SUBJECT: Safety Recall 05S28 - Supplement #9
Certain 1994-1996 Model Year Bronco, 1994-2002 F-150 through F-550, 1997-2002 Expedition, 1998-2002 Navigator, 2002 Blackwood, 1994-1996 E-150/250/350, 1996-2002 E-450, 2000-2002 Excursion, and 1998 Explorer and Mountaineer vehicles equipped with Speed Control – Speed Control System Modification

New! REASON FOR SUPPLEMENT #9

Safety Recall 05S28 - Supplement #9

FIGURE 5

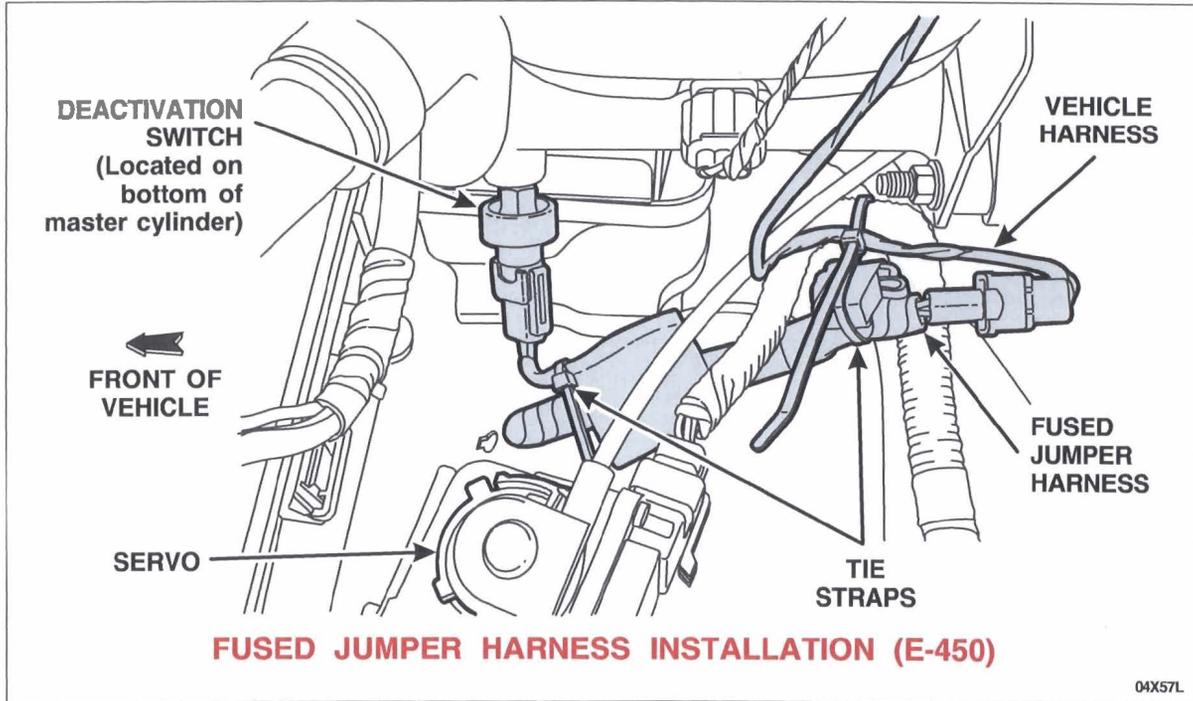
1. Connect the fused jumper harness (14A411) to the speed control deactivation switch and the vehicle harness.
2. On E-450 models, secure the 2-wire take out to the larger portion of the fused jumper harness before installation, as shown in Figure 5.

4. Secure the jumper to the existing harness with tie straps, making sure the fuse holder is positioned vertically with the cap facing upward. Wrap the tie straps underneath, then over the top of the existing harness and verify proper fuse holder orientation. See Figures 4 and 5.

FIGURE 7

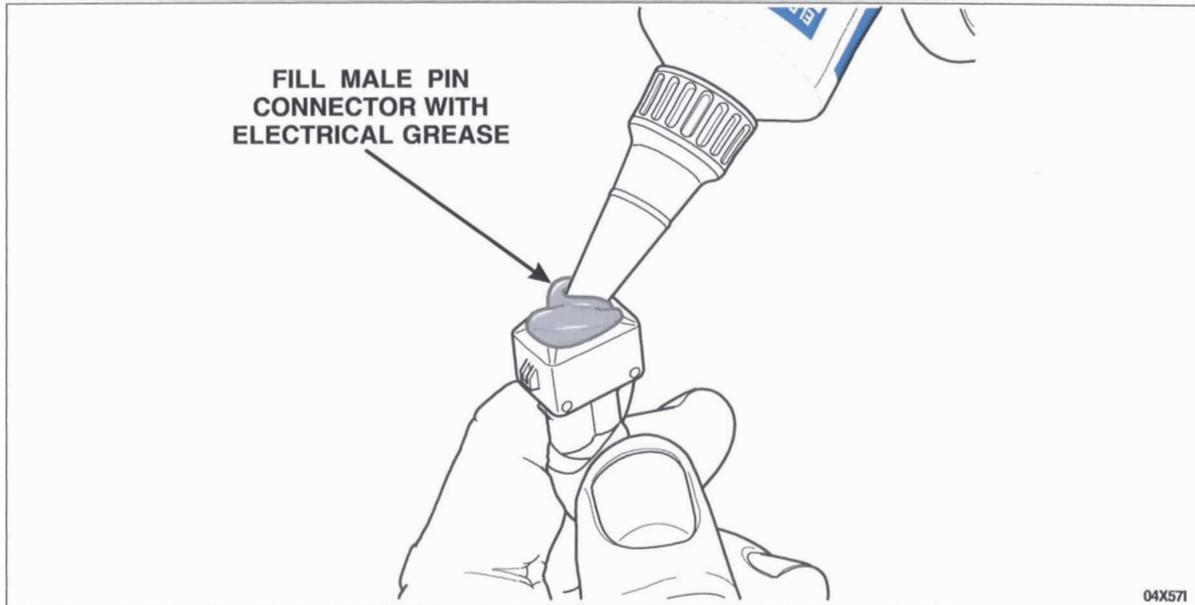
New, more robust, electrical grease (Electrical Grease II, Part # XG-15-A) is available. It is to be used when performing Labor Operation 05S28E. The instruction for Labor Operation 05S28E is revised with the part number for the new electrical grease. For all future 05S28 repairs, dealer technicians are directed to use Electrical Grease II XG-15-A where the original XG-12 was called for previously.

3. Install the *new* speed control deactivation switch into the master cylinder and tighten to 18 Nm (13 lb-ft).
4. **With the speed control servo disconnected, use shop air *only* to blow the speed control deactivation switch harness electrical connector and the servo connector dry of any trace of brake fluid. DO NOT USE ANY TYPE OF SOLVENT TO CLEAN THE CONNECTORS.**
5. Cut approximately 3 mm (1/8 in) off the grease tube applicator tip.
6. **Before installing the jumper harness, fill the vehicle harness end of the jumper (male pin connector end) with Motorcraft Electrical Grease II XG-15-A. See Figure 7.**

FIGURE 9

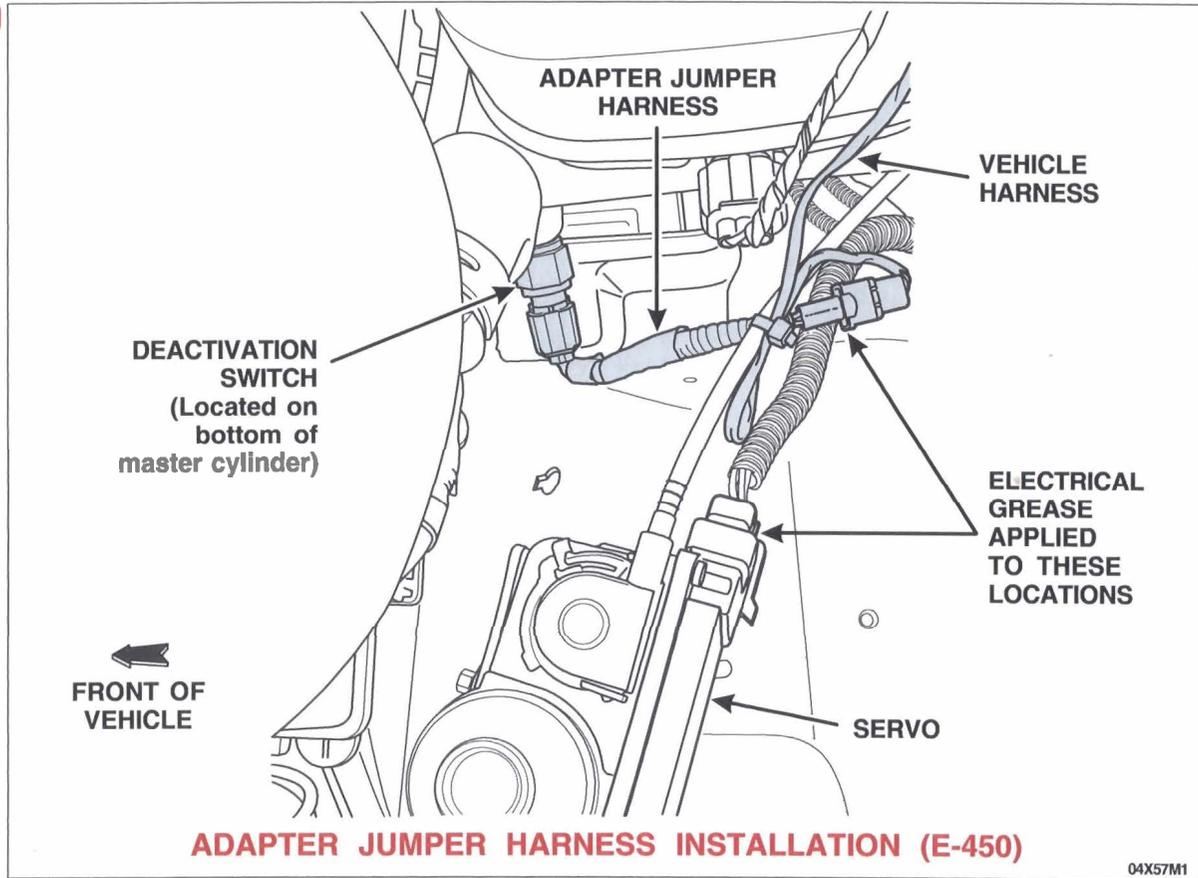
7. Install the adapter jumper harness by connecting it to both the deactivation switch and the vehicle harness. Using the provided tie strap, secure the jumper harness to a nearby component such as the speed control cable or another wire harness. See Figures 8 and 9.

FIGURE 10

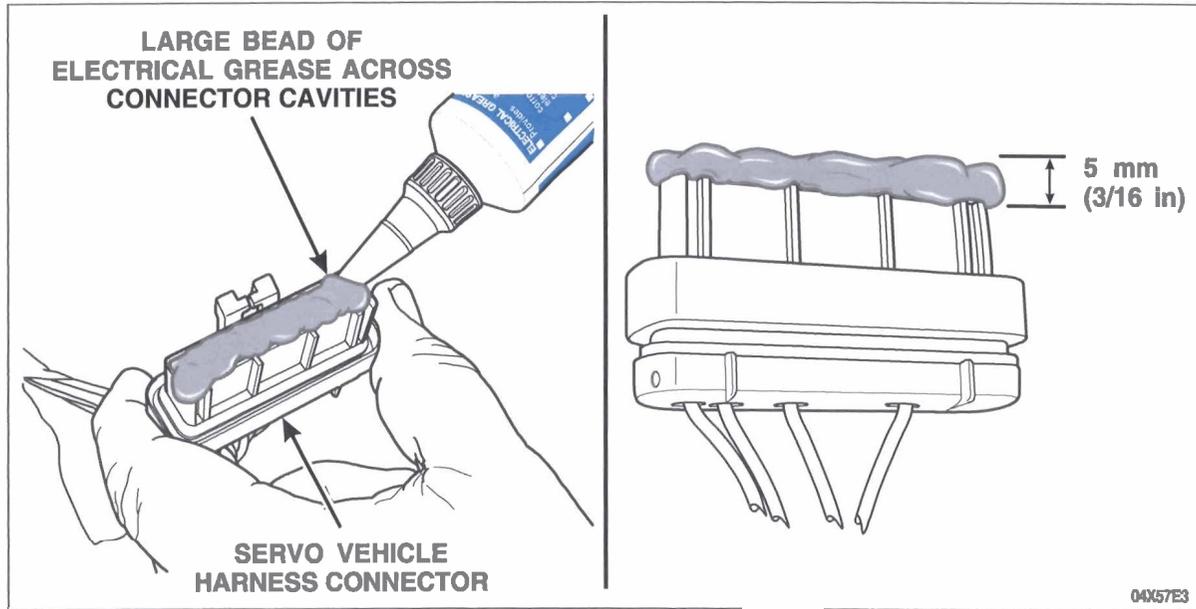
8. **CAUTION:** Be sure to apply an adequate amount of grease to the vehicle harness connector only. **DO NOT** apply the grease directly to the connector of the servo module.

Apply a 5 mm (3/16 in) high bead of Motorcraft Electrical Grease II XG-15-A across the entire width and length of the servo vehicle harness connector. See Figure 10.
